DEVELOPMENT CONSENT  
Development Consent No. 1510875  
18 DEC 2014  
SUTHERLAND SHIRE COUNCIL

REVISIONS TO ADDRESS DEFERRED COMMENCEMENT CONDITIONS

PROJECT STATUS  
APPLICATION FOR DEVELOPMENT  
PROPOSED RESIDENTIAL UNIT DEVELOPMENT

ADDRESS  
10-14 MOANI AVE  
GYMEA  
CLIENT  
I J NORMAN NOMINEES Pty Ltd

**2 SOUTH ELEVATION CITYVIEW**  
1 : 100

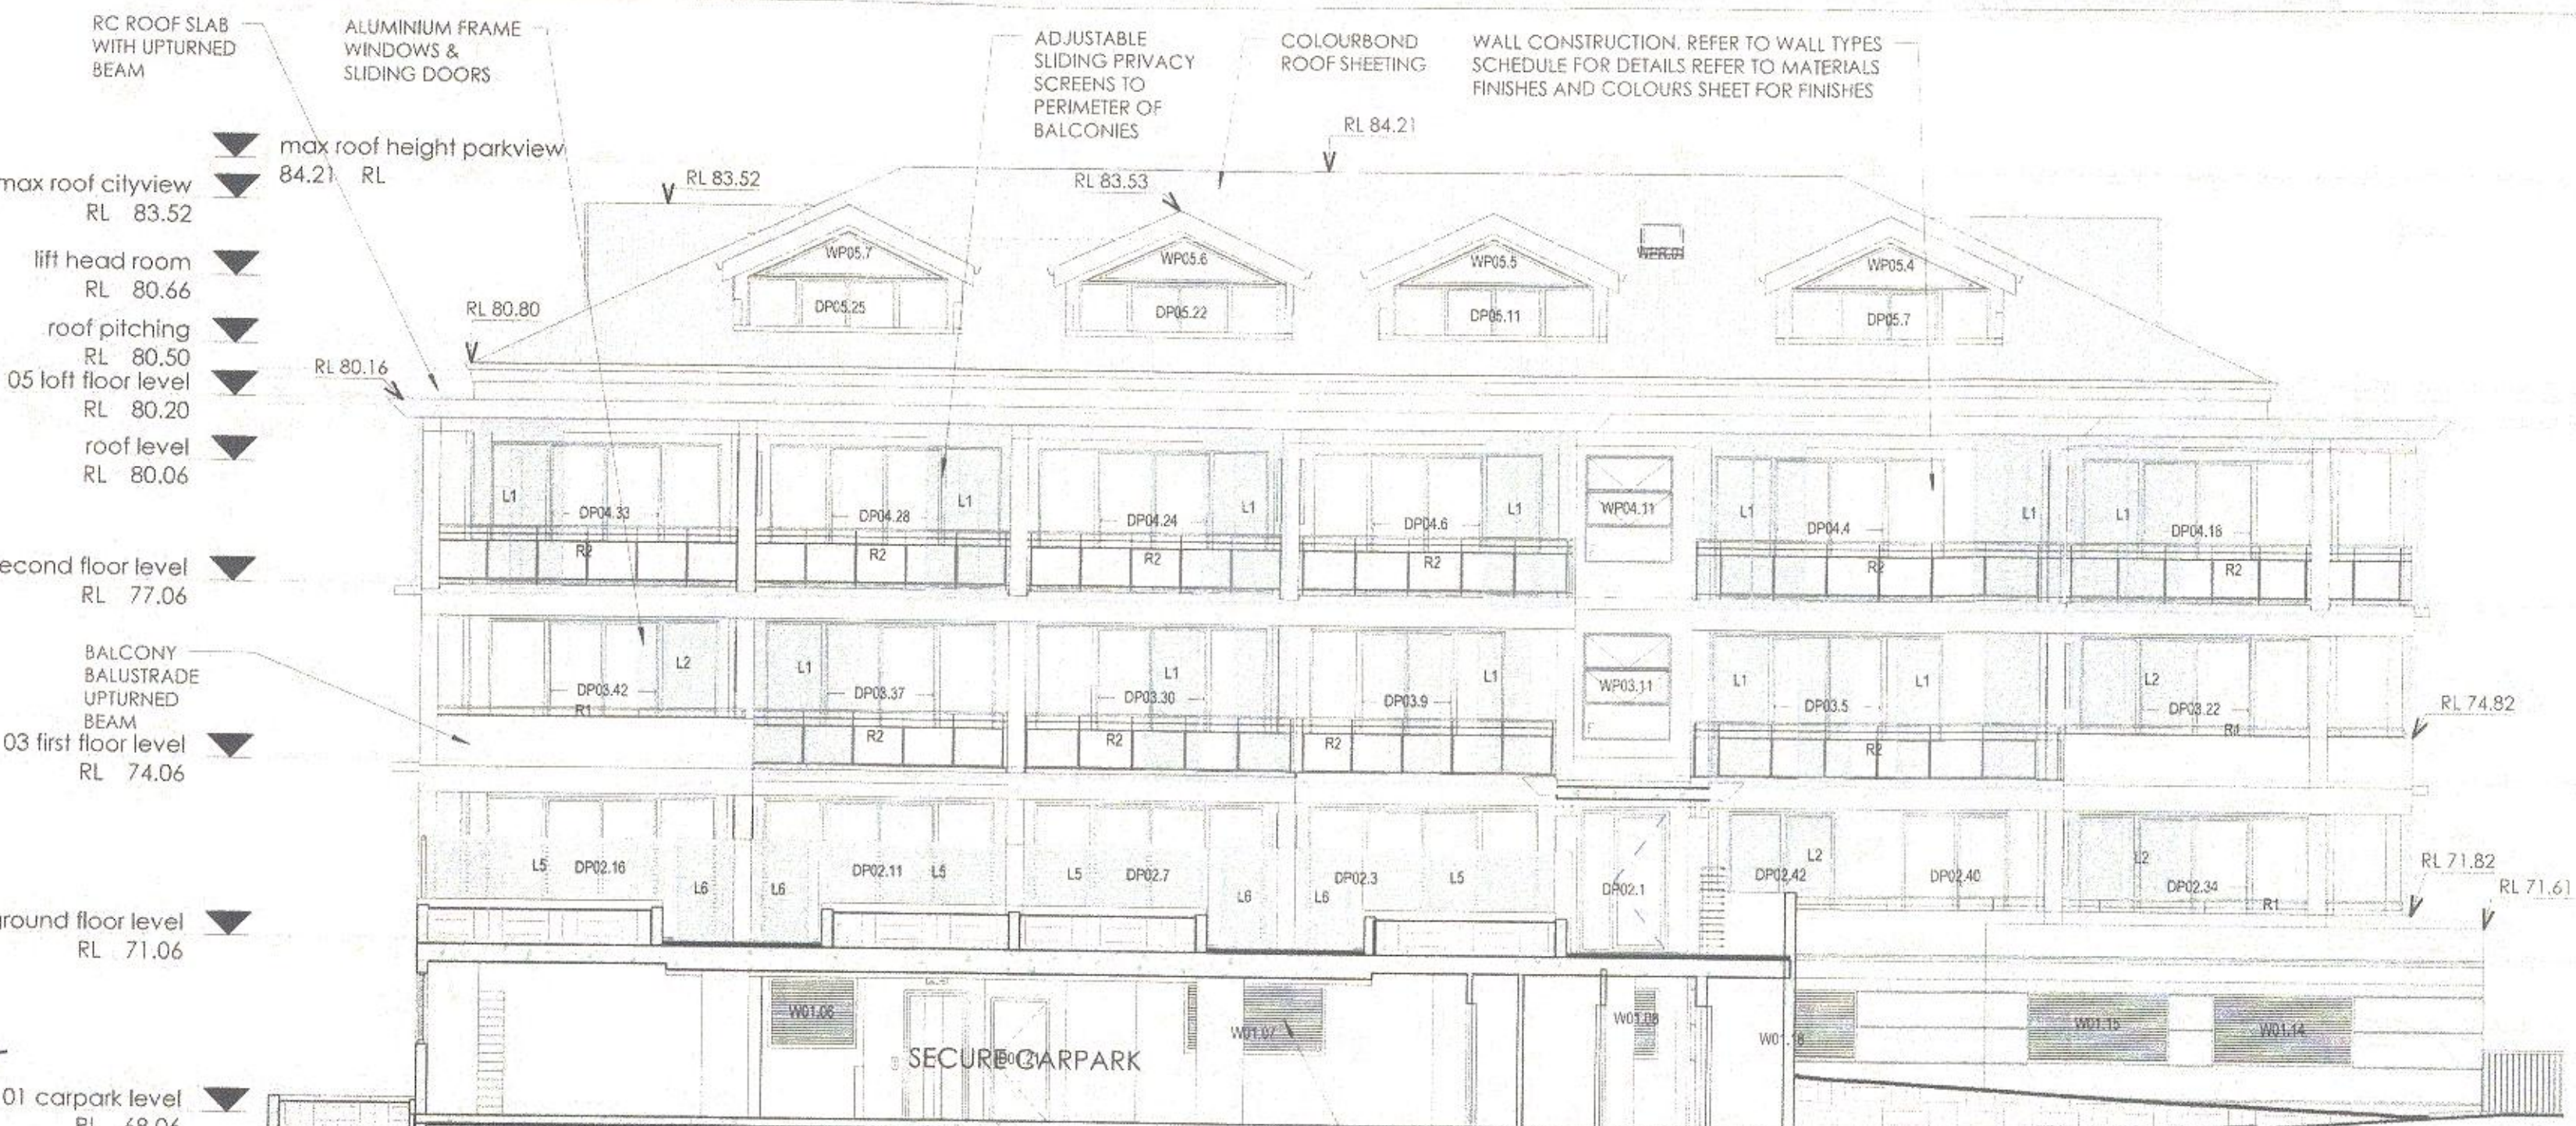
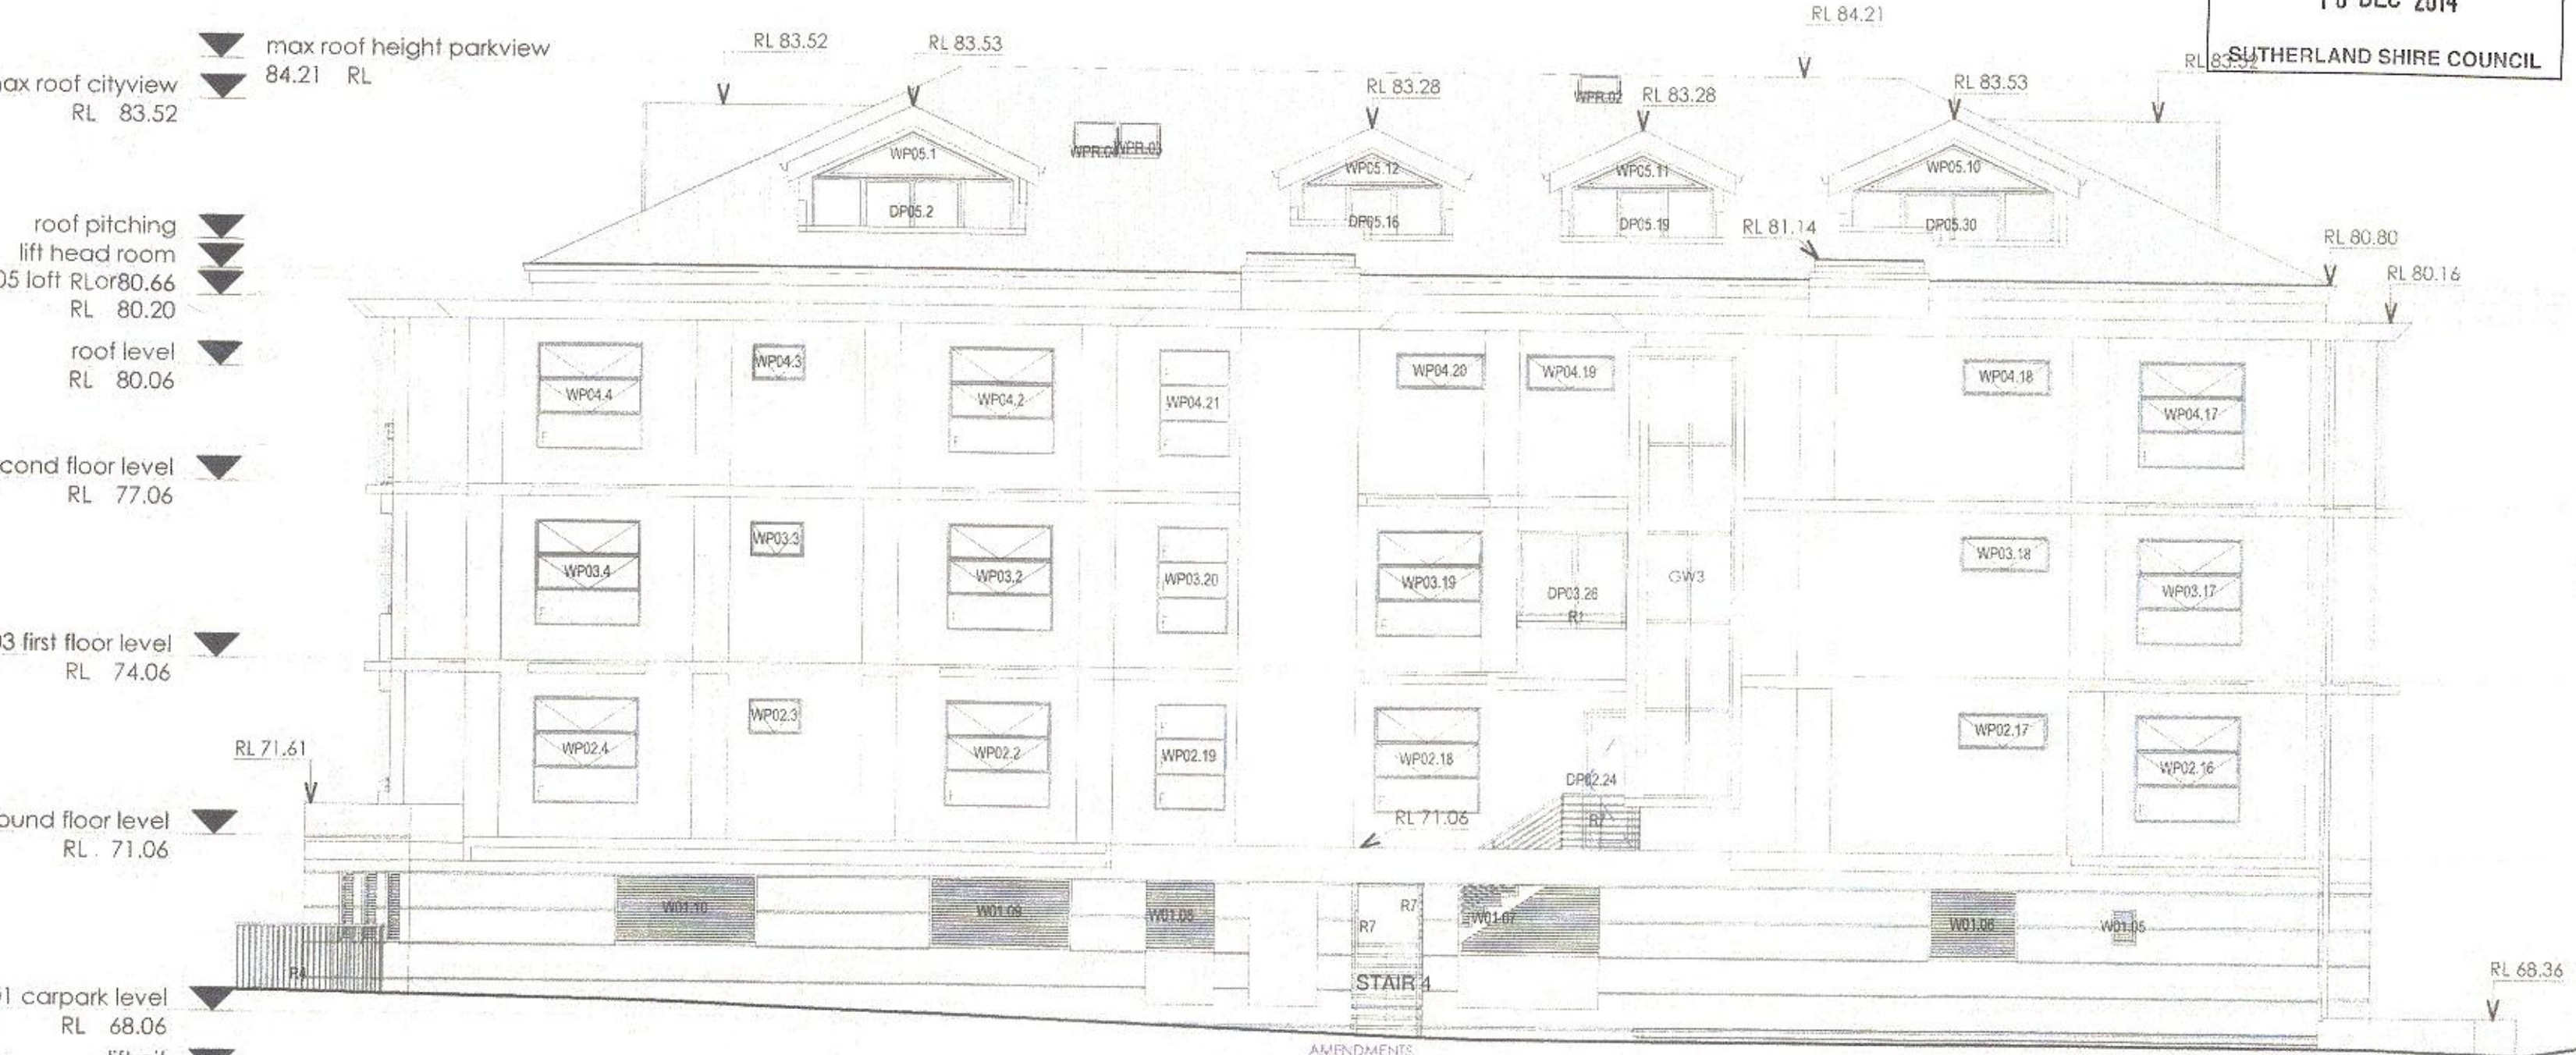
**Division of 2 additional accessible carpark spaces.**  
An application to modify the development consent has been lodged to remove this condition, as it was included in the consent in error.

**Relocation of carpark access to ensure pedestrian safety around L2.**  
The secure carpark has been redesigned. The space around the lift tower, the adjacent carpark L2, there is now adequate space for maneuvering around the carpark space. The inclusion of a barrier at the entry of the lift tower ensures pedestrian safety. The revised carpark design has been certified by Accessible Building Solutions (ABS) in accordance with the Conditions 24, 41 and 42.

**Relocation of Pedestrian entry.**  
The design of the entry has been modified in accordance with the preliminary plans produced at the JNH meeting, but with further modification in order to meet the needs contained in Council's landscape design, including additional walkway to meet the lift landing at the required level design level. The design of the pedestrian entry has been certified by Accessible Building Solutions (ABS) in accordance with the Conditions 24, 41 and 42.

**Extension of carpark level.**  
The path and stairs have been relocated to be adjacent to the podium, and landscaping extended adjacent to the area.

**Extension of carpark level.**  
The carpark level has been amended to show a darker colour to the carpark level.

**Extension of podium level.**  
The podium on the podium level has been extended to provide covered access between the Cityview and Parkview buildings.

**Widened Courtyards P12, P13, P14, P15.**  
The podium level courtyards have been extended to 1m depth. Adjustable louvre privacy screens have been included on the northern wall of each courtyard to 1.8m high. Concrete garden planters have been provided in the courtyard area in front of each courtyard.

**Widened access to eastern external stairs.**  
The eastern external stairs have been widened to align with path through podium terrace.

**Widened access to eastern external stairs.**  
The upper level of these apartments have been redesigned to locate the staircases between the bedroom and study, as shown on plans as tabled at JNH meeting.

**Relocation of carpark level and lift.**  
The carpark level and lift tower have been redesigned to align with the carpark level and ground floor level above and the approach to lift 2 have been redesigned as tabled at the JNH meeting, with minor amendment to ensure accessibility. The design has been approved by Accessible Building Solutions (ABS) in accordance with the Conditions 24, 41 and 42.
